Stage 1 Road Safety Audit

Gort Town Centre Public Realm Scheme

On behalf of **Galway County Council**

3.3.19 Station Road – Pedestrian Crossing Visibility

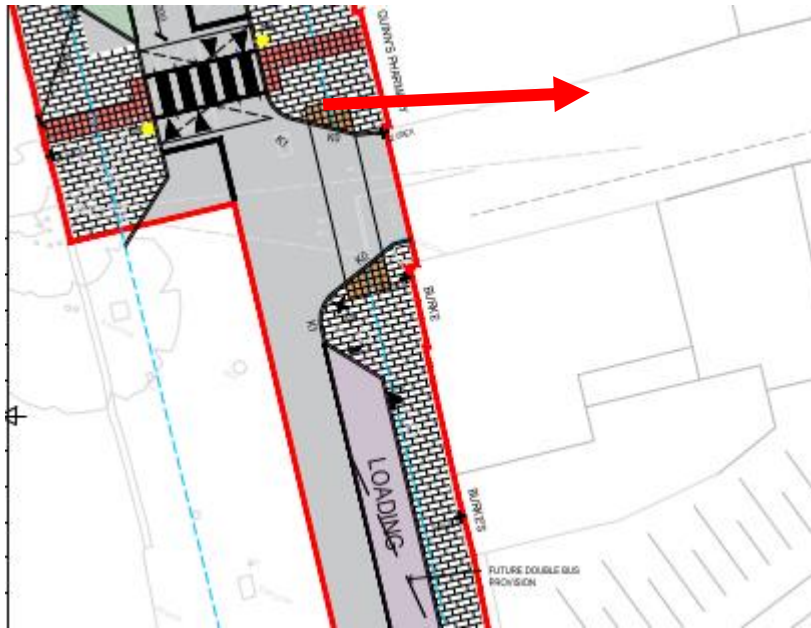
Problem: Pedestrians crossing north south of Station Road have their visibility to traffic exiting Station Road restricted by the building.

Hazard: Pedestrians may commence their road crossing and be subject to vehicle strikes.

Recommendation: The Design Team should relocate the tactile paving and dropped kerb closer to the Ennis Rd carriageway edge.

3.3.20 Gort Medical Centre – Car Park

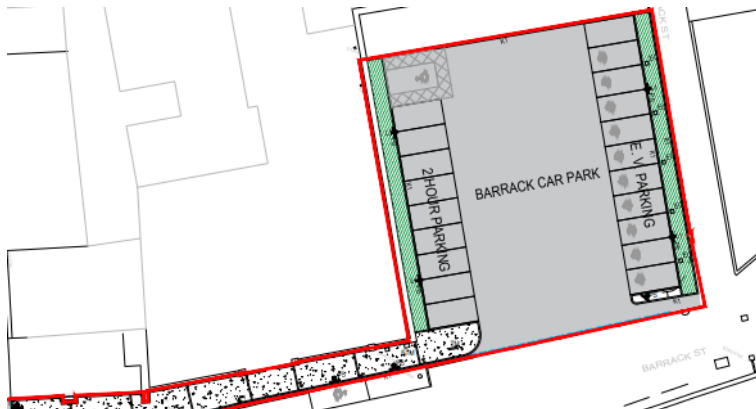
Problem: Motorists' visibility to pedestrians crossing the entrance to Gort Medical Centre is very restricted, both by boundary walls and the angle of the entrance. It was noted during the site visit this car park is very busy and has a high turnover rate.

Hazard: Pedestrian / vehicle collisions may result.

Recommendation: The team, in consultation with the medical centre, should undertake works to improve the existing car park access.

3.3.22 Barrack Street – Car Park Disabled users Parking

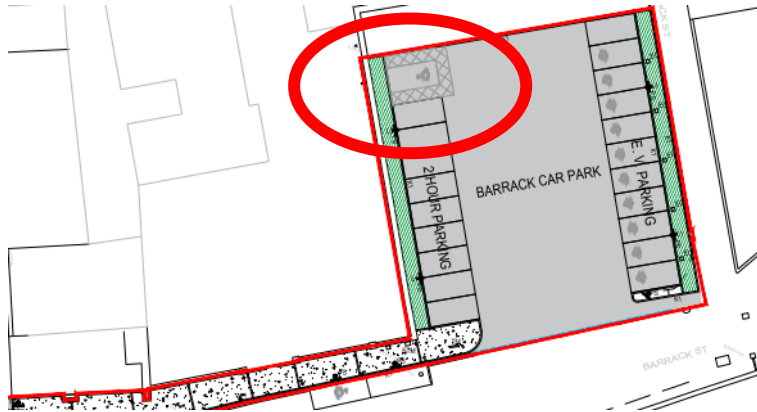
Problem: The disabled user parking space within the car park is not located adject to a segregated footpath. Disabled users will be required to walk through the trafficked area of the car park in order to access the footpath.

Hazard: Impact from passing or reversing vehicles may occur.

Recommendation: The Design Team should relocate the disabled user parking spaces, such that direct access to a segregated footpath can be achieved.
